Amendment to the Application to the
North Dakota Public Service Commission
for
Consolidated Certificate of Corridor
Compatibility and Route Permit

Case No: PU-11-696

**AVS-Neset 345-kV
Transmission Project**

July 2014

Figure 1.2-1
 Basin Electric Power Cooperative
 Antelope Valley Station to Naset
 345-kV Transmission Project
 Overall Proposed Project Area and
 Proposed Corridor/Route

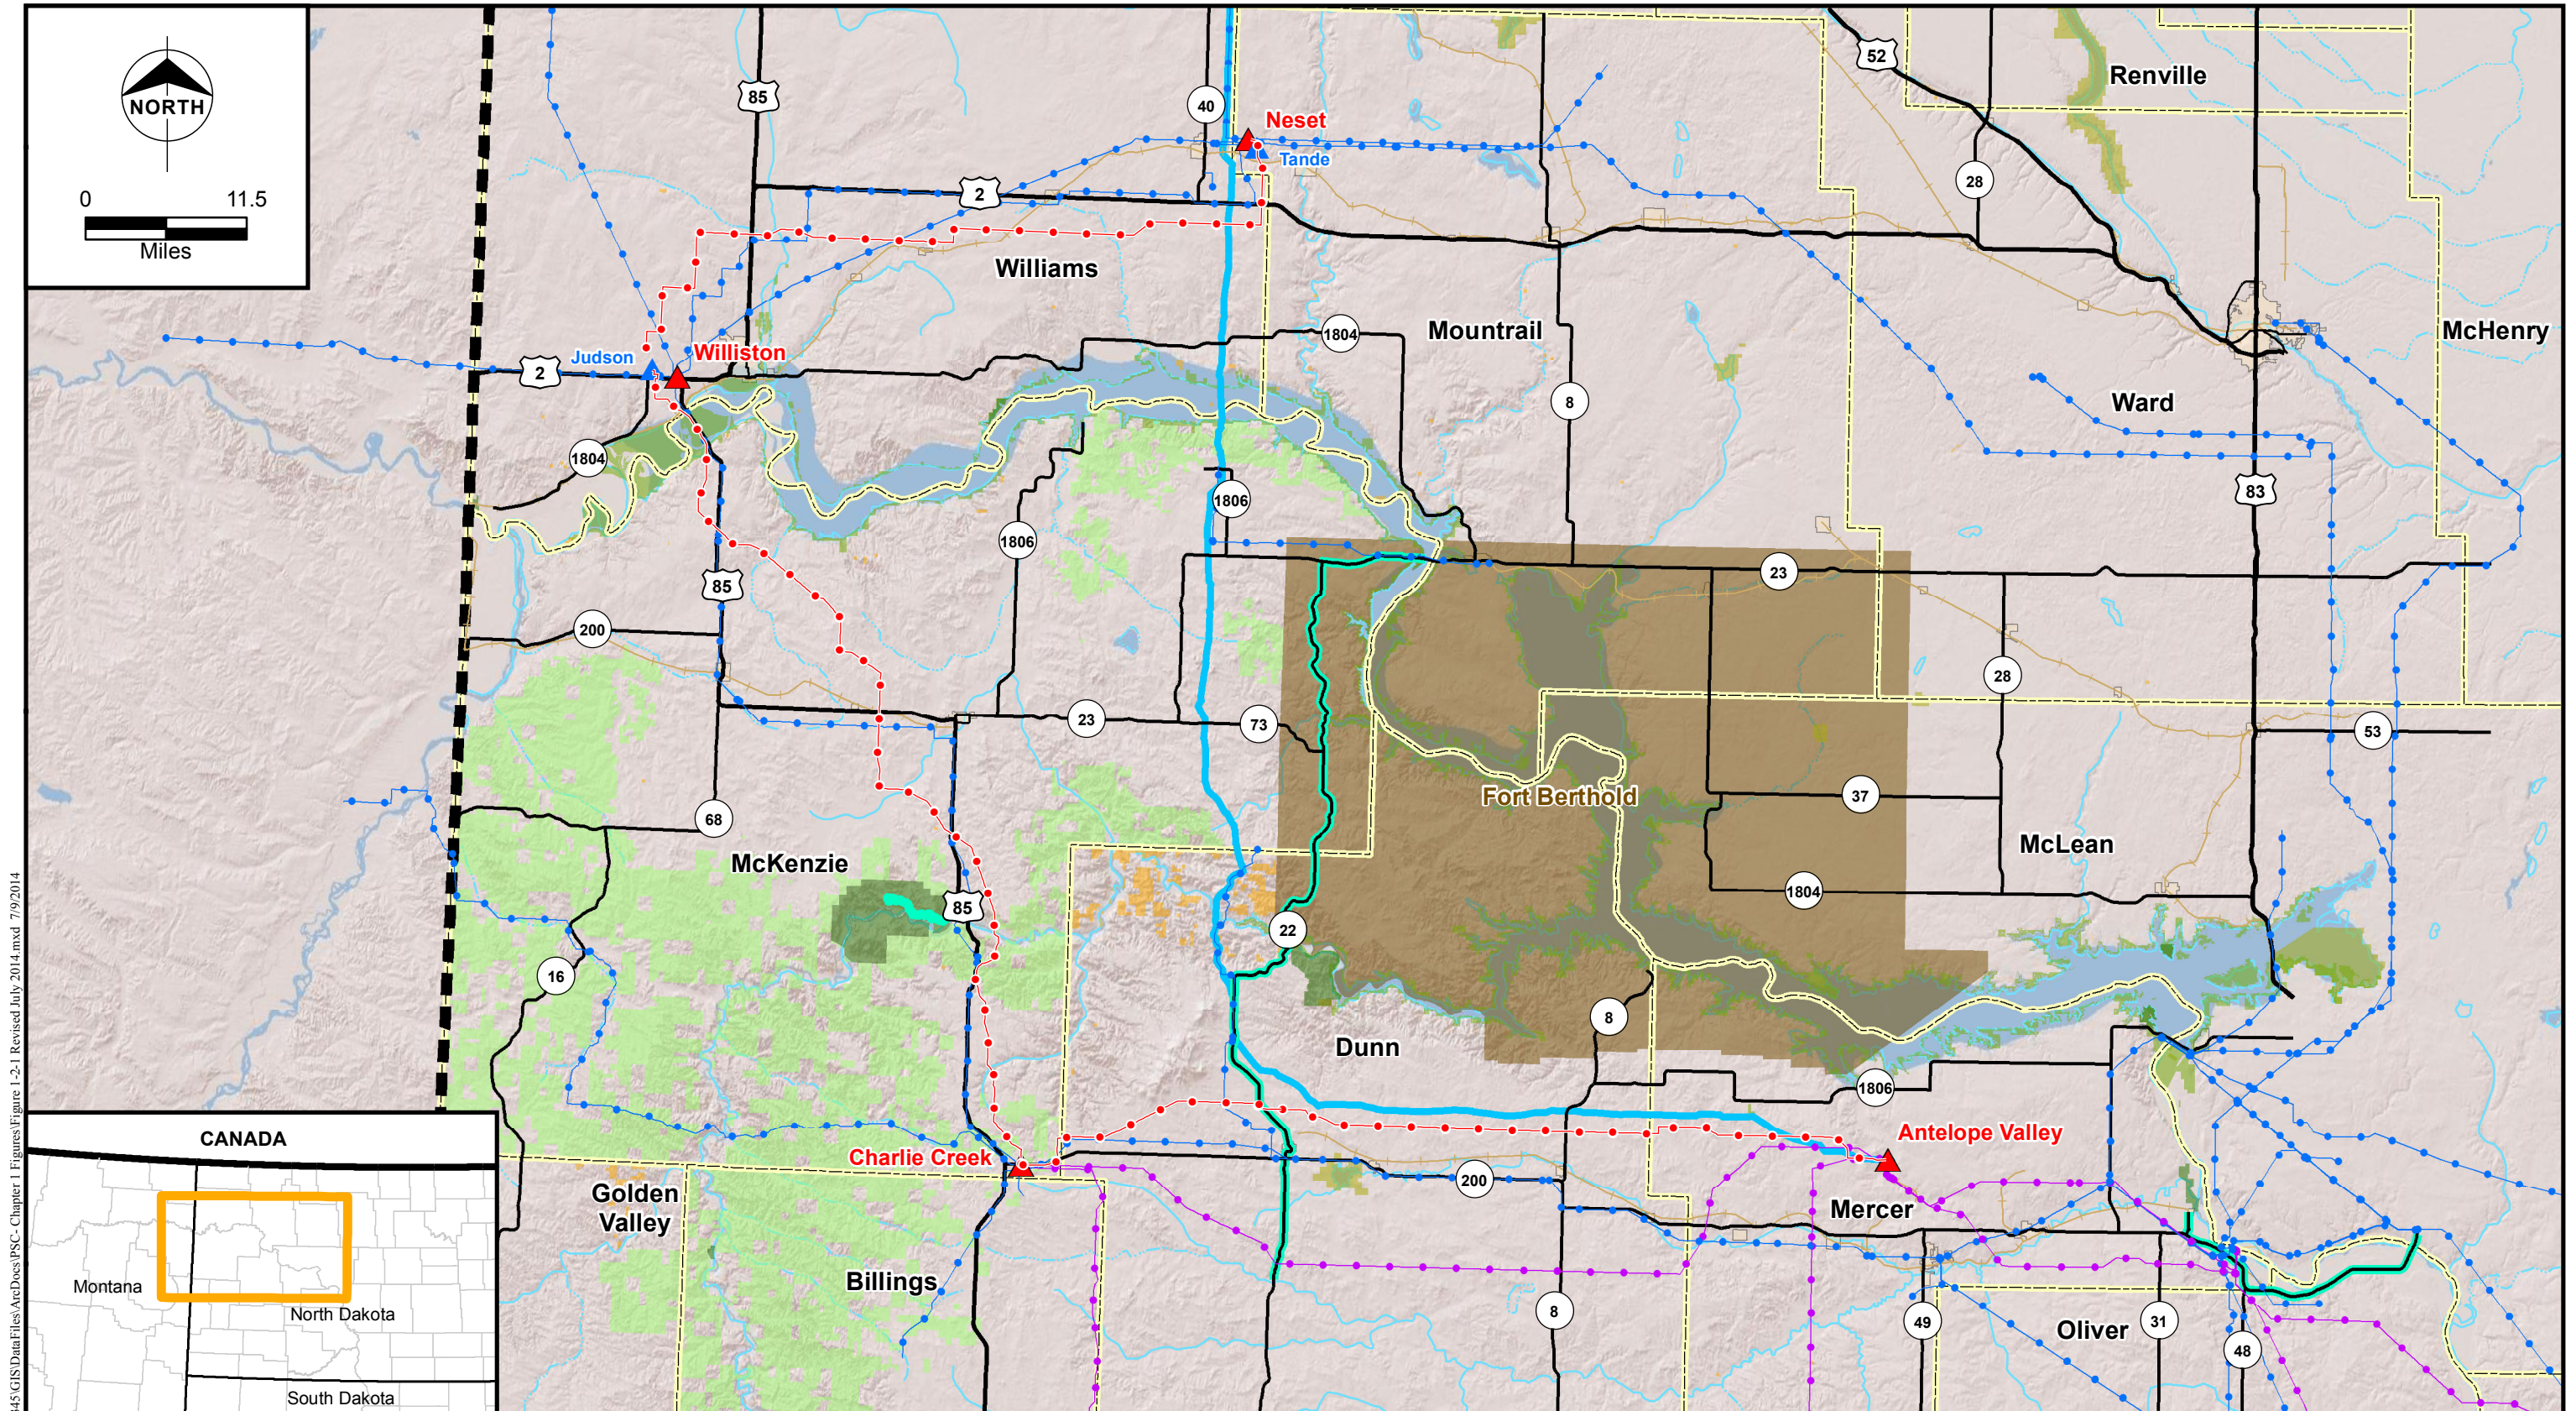
No changes from Corridor/Route revisions. Figure 1.2-1 has been updated to include the revised Corridor/Route.

Figure 4.2-5
Basin Electric Power Cooperative
Antelope Valley Station to Neset
345-kV Transmission Project
Temporary Construction Material
and Equipment Laydown Areas

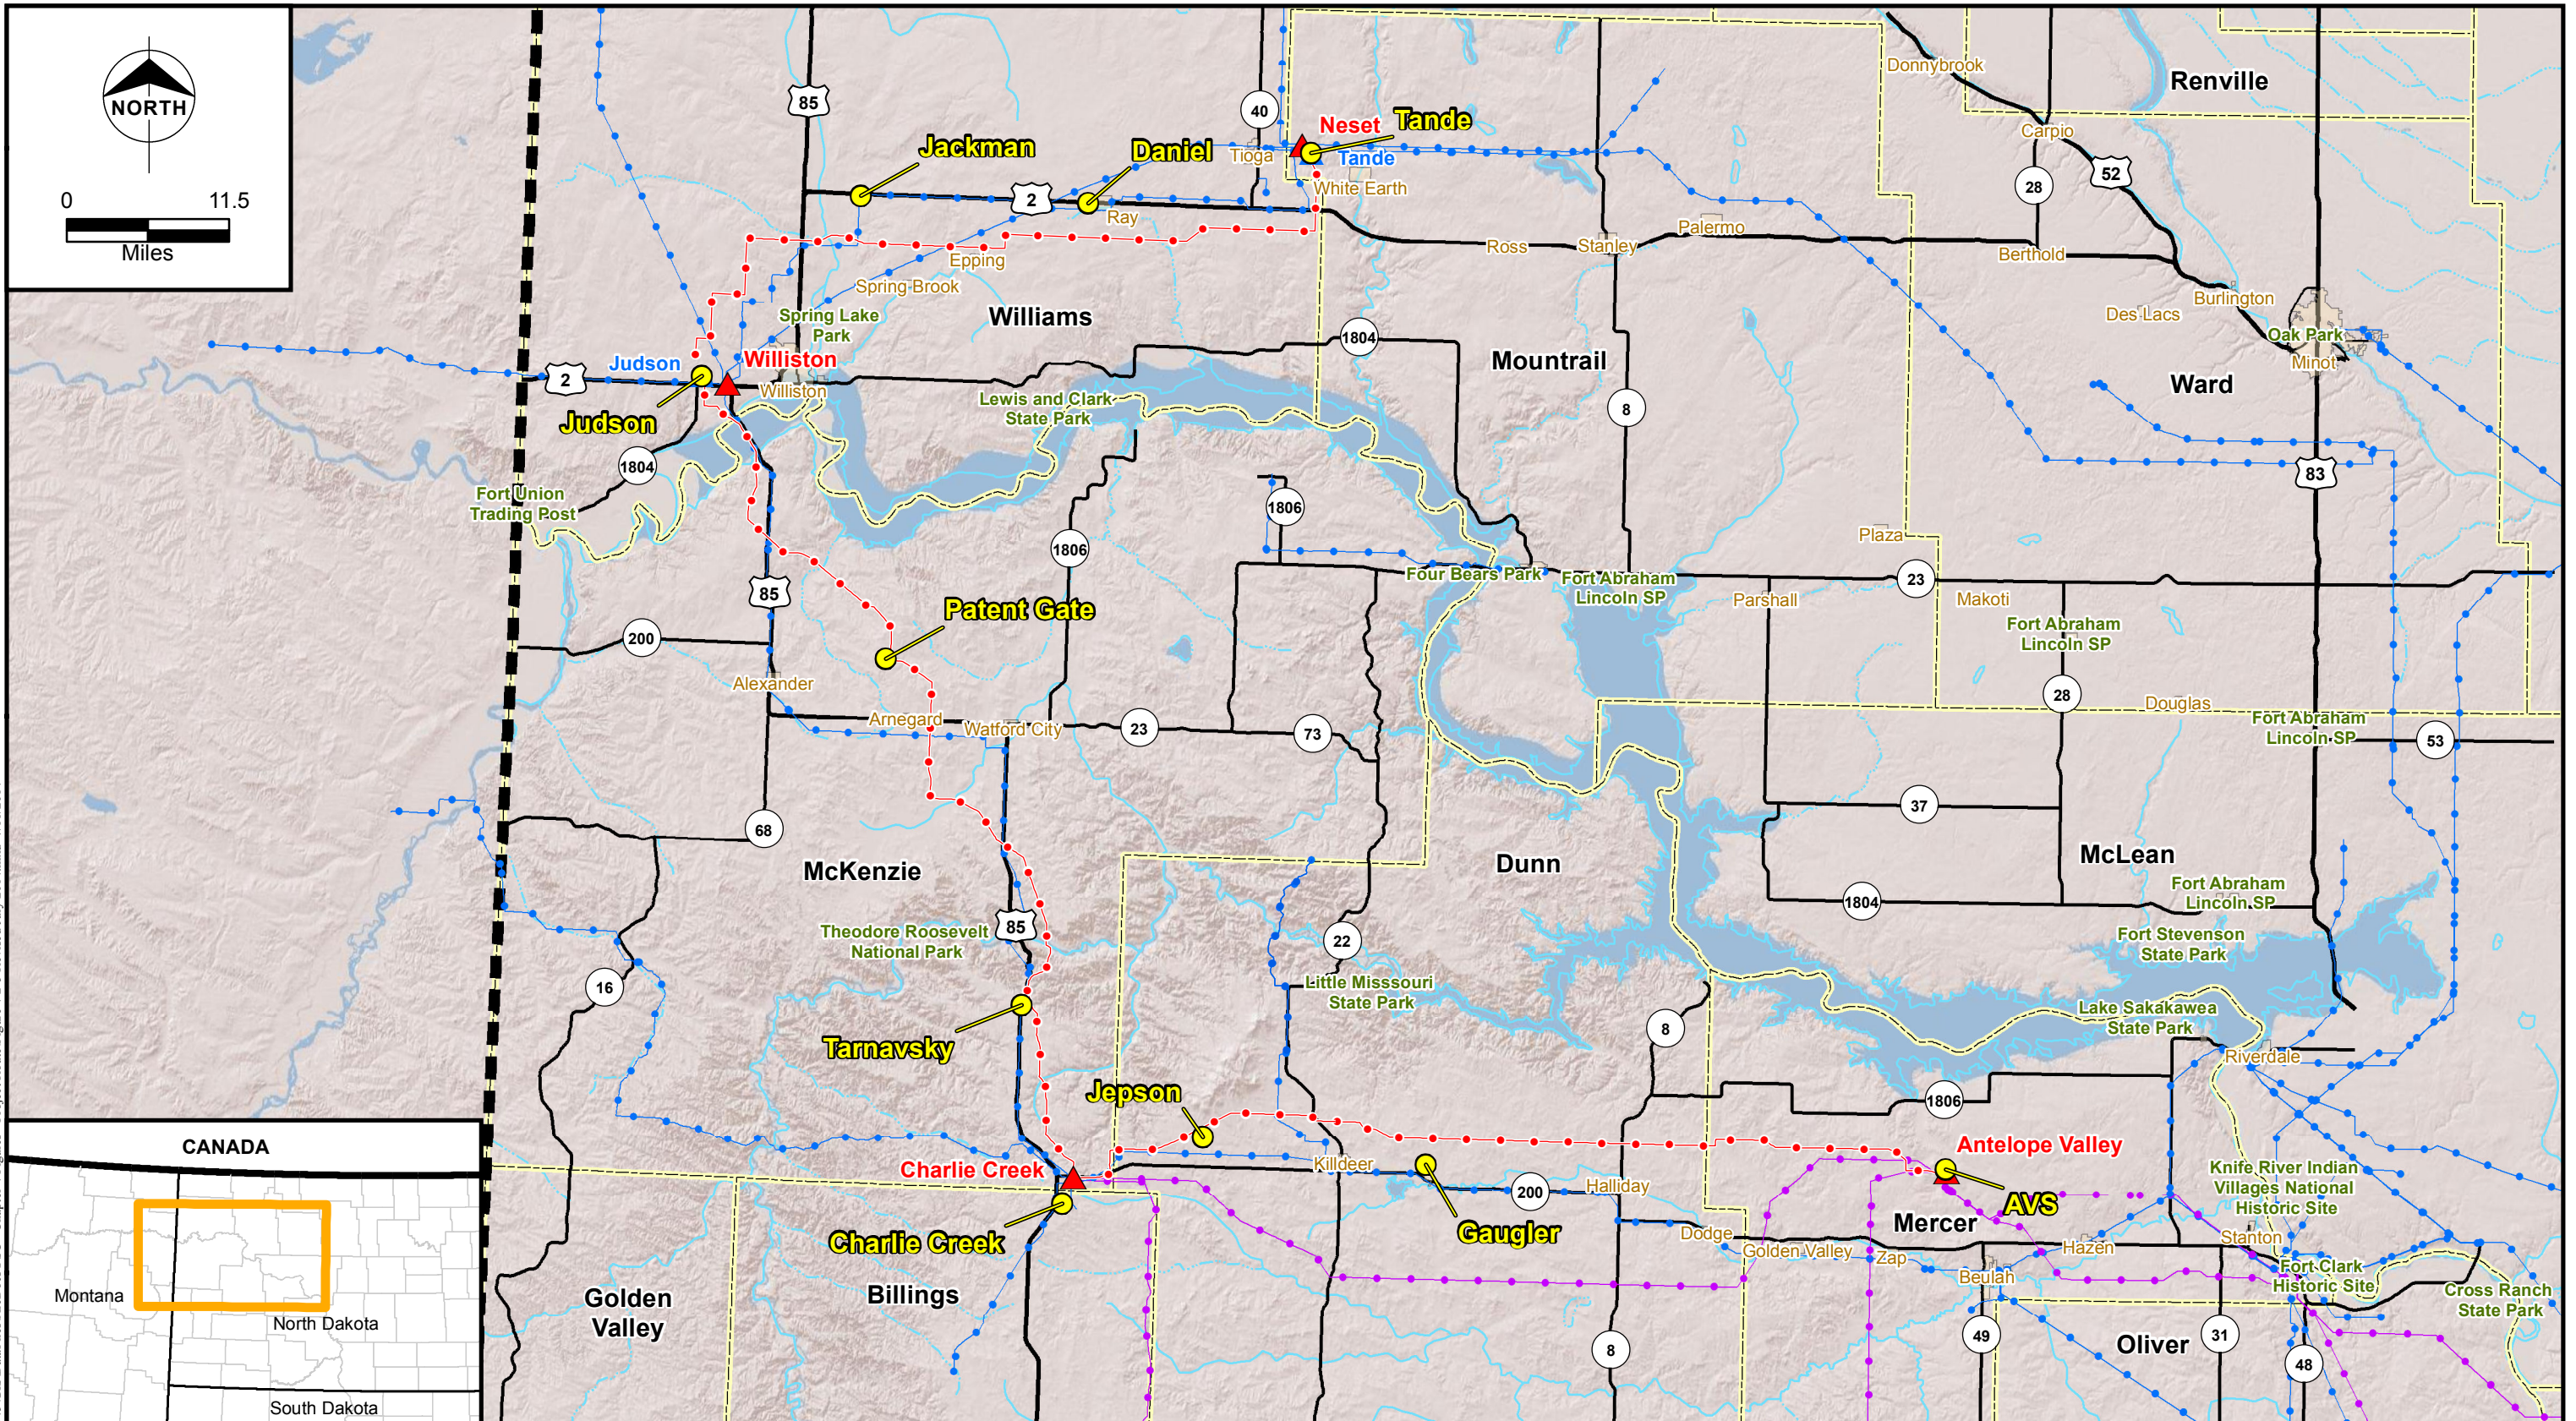
Ongoing activities and preparations for construction identified a previous laydown yard south of the Charlie Creek Substation. The Charlie Creek Material Yard is located in Billings County for use as a vehicle service area, construction trailer location, and material laydown yard. Figure 4.2-5 has been updated to show the location of the Charlie Creek Substation and the location of the nearby construction staging and material laydown yard. Basin Electric will obtain the necessary Conditional Use Permit (CUP) from Billings County for the temporary use of this location during construction. Basin Electric will provide the CUP as it becomes available.

An additional material laydown yard will be utilized in the land parcel supporting the future Patent Gate Substation and will be referred to as the Patent Gate Material Yard. Figure 4.2-5 has been up-dated to show the location of the Patent Gate Material laydown yard. This material yard was incorporated into the McKenzie County Conditional Use Permit and has been provided previously filed to this Commission docket.
